4250607 INLETS, MANHOLES, AND JUNCTION BOXES  
COMMENTS FROM INTERNAL/INDUSTRY REVIEW

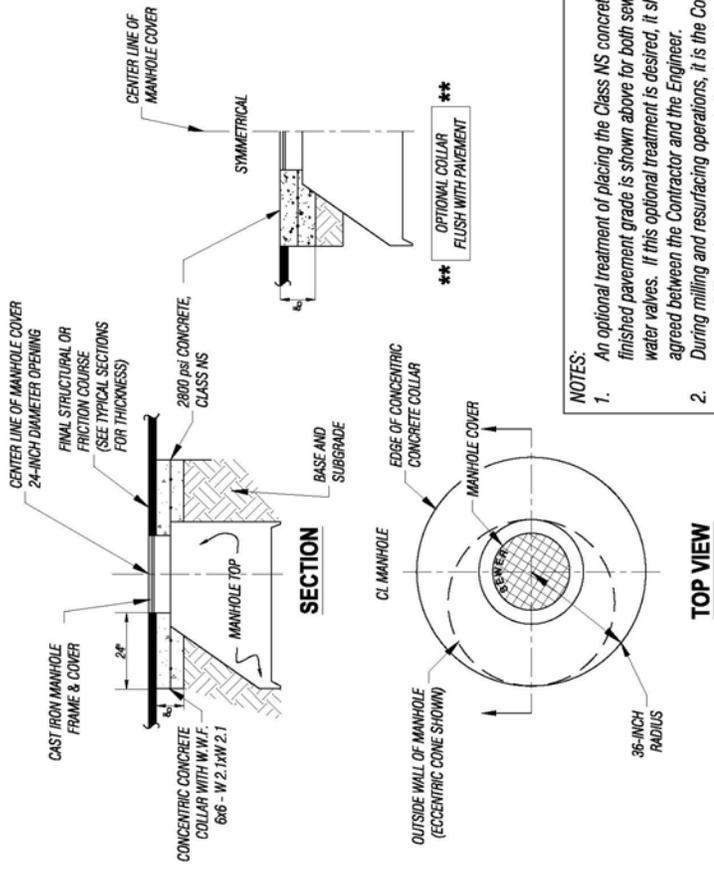
Allowing adequate curing time for the concrete collars at valve boxes and sewer manholes is crucial to the structural durability of the adjustment. On many night-work RRR projects, FDOT needs to have the highway open to traffic in the morning, when the concrete has not had time to set-up enough to withstand wheel loads by that time. I request that FDOT provide a solution to that problem. Perhaps a special high-early strength, fast-curing concrete mix (i.e. accelerator) be made part of the 425-6.7. We would be interested in receiving additional direction on permissible FDOT concrete mixes for valve and manhole adjustments.

DATE		BY		DESCRIPTION	
2/20/11	SGA			ADDED OPTIONAL CONCRETE FLUSH SECTION AND NOTES	
STATE OF FLORIDA		DEPARTMENT OF TRANSPORTATION		ROAD NO.	
LEON COUNTY		FINANCIAL PROJECT ID		LEON	
SHEET NO.		UTV-1		WATER VALVE BOX & SEWER MANHOLE ADJUSTMENT

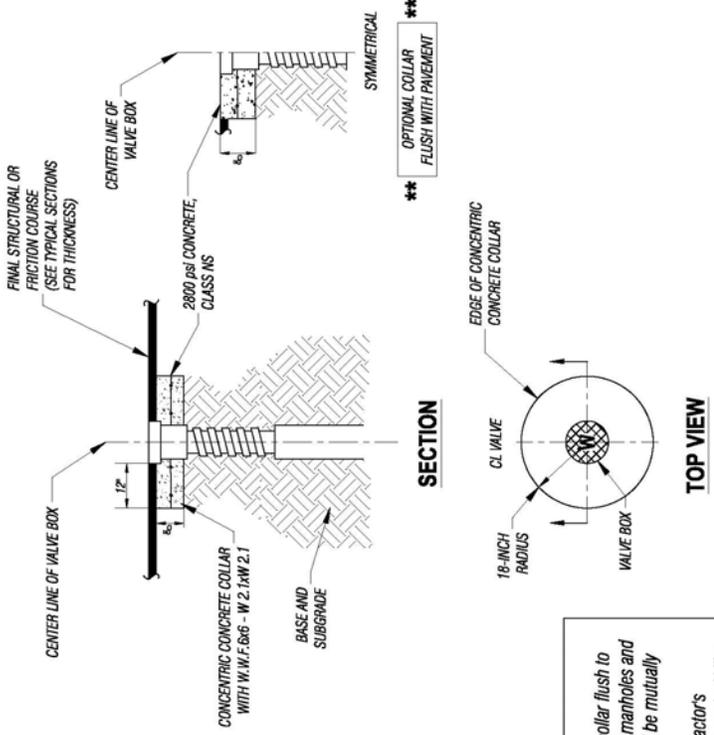
Attached is a drawing provided to you as "industry comment" to FDOT's proposed amendments to 2010 UAM, Spec Section 425, and Index 201. This is a draft detail that I put together last year, before the FDOT ban on concrete collars in state highway pavements. For your consideration.

1. An optional treatment of placing the Class NS concrete collar flush to finished pavement grade is shown above for both sewer manholes and water valves. If this optional treatment is desired, it shall be mutually agreed between the Contractor and the Engineer.
2. During milling and resurfacing operations, it is the Contractor's responsibility to locate, expose, and allow immediate access by Utility Agency Owner (UAO) personnel to any valves or manholes for the purpose of emergency utility operations or maintenance. The Contractor must assign a representative that will be available 24 hours-a-day, seven-days-a-week to coordinate emergency location and exposure of valves and manholes, as requested by the UAO.
3. Manhole adjustment grade rings shall be a minimum of 3 inches thick and shall not exceed 18 inches in height.

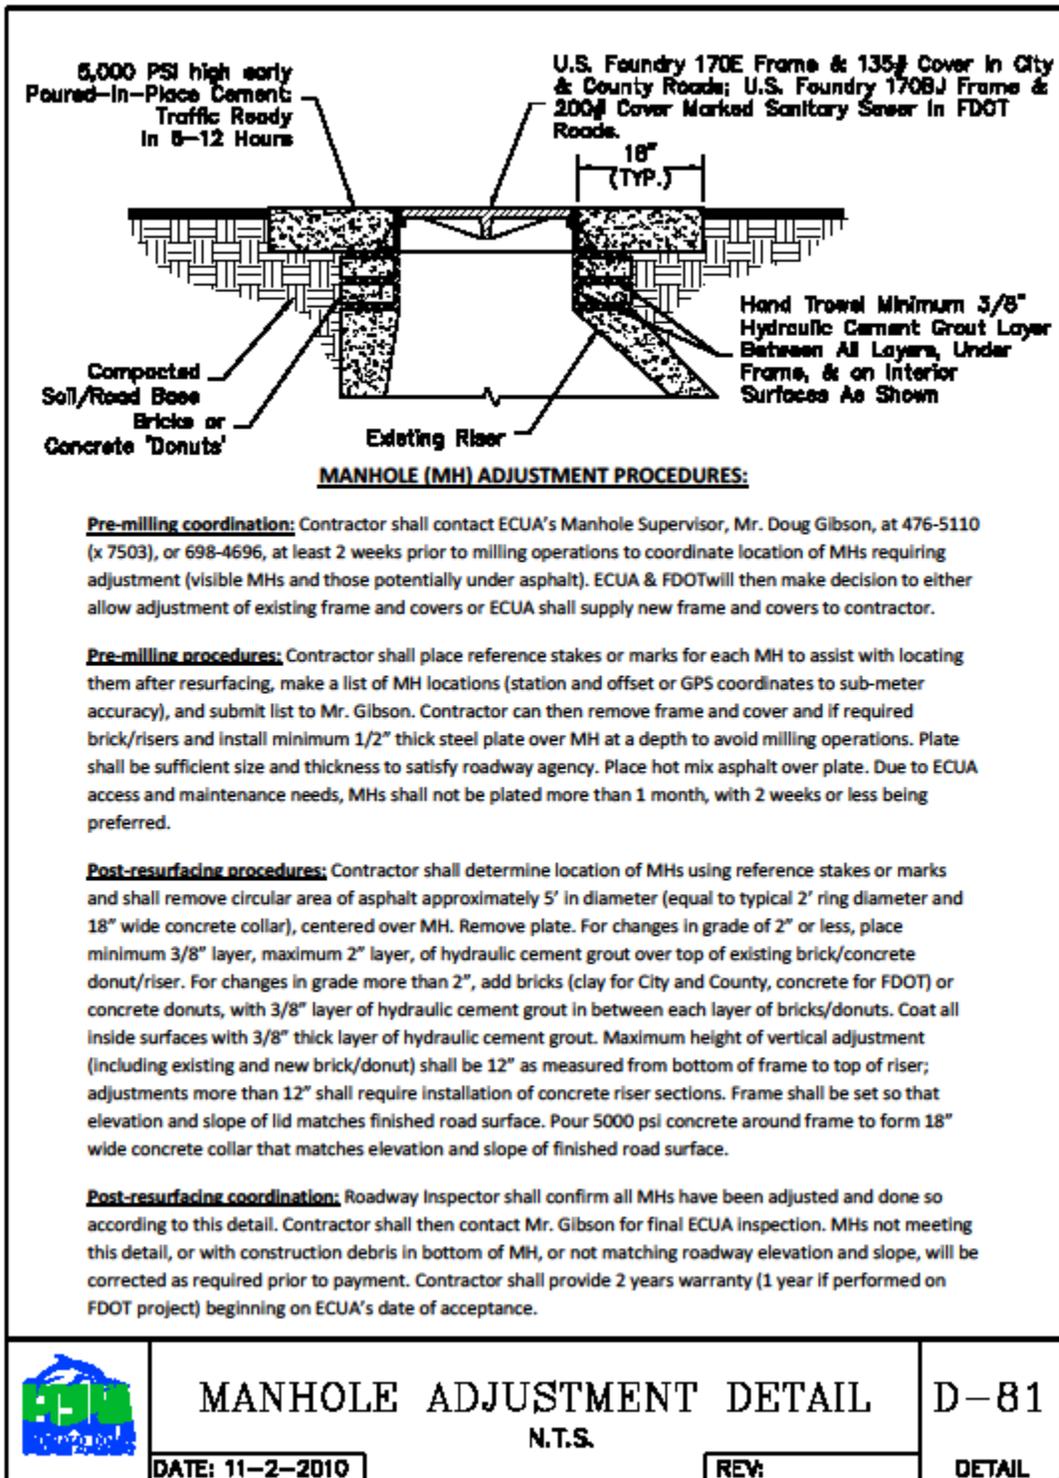
3. We actually have developed a detail (see below, D-81 Manhole Adjustment Detail.pdf) to try and standardize the best means and methods we know. As you can see, it emphasizes hand spread mortar layers under and between bricks and frames. This is critical because rebuilding the section from the riser to the frame needs to be seen as a structural course, holding the frame in place, and eliminating shifting and concrete cracking.

4. Our MH Supervisor believes that if mortar beds were used under frames, instead of concrete, that cracked concrete collars would be almost a thing of the past.
